RE: 848-852 Main Street
Site Plan Special Permit

On behalf of our client, Acorn Deck House Company, we have revised the Site Plan for the referenced project to address concerns raised in Interdepartmental Communications, as follows:

Roland Bartl, Planning Director Memorandum

Engineering Department Interdepartmental Communication

LOT A-1
SITE PLAN
MAIN STREET
ACTON, MASS.

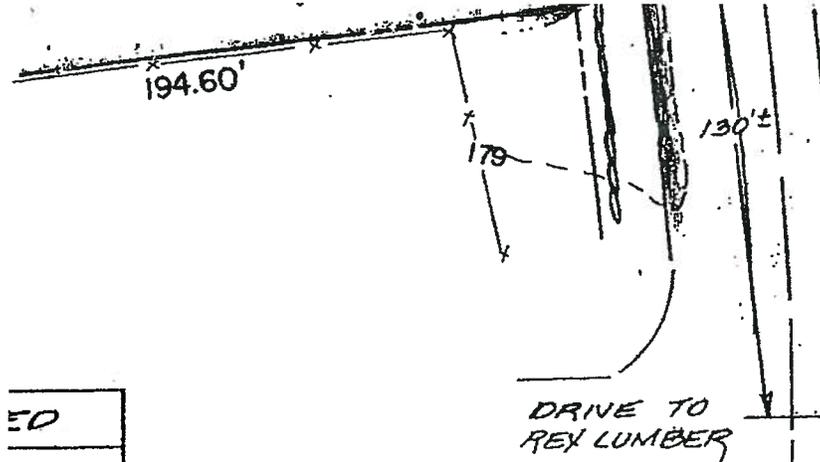
The Site Plan Special Permit for Deck House Condition 2.7 and Limitation 3.2 (attached) require the applicant to obtain Board approval prior to any change. As shown on the attached plan Parcel B which is currently part of Deck House will be joined with Lot C. Parcel A which is currently part of Lot C will be joined to the Deck House lot.

The site plan, showing the lot change in red, is attached. The A.N.R. plan, which is to be submitted to the Planning Board for endorsement is also attached. Thank you for your time in consideration of this matter. Please call our office if you have any further questions.
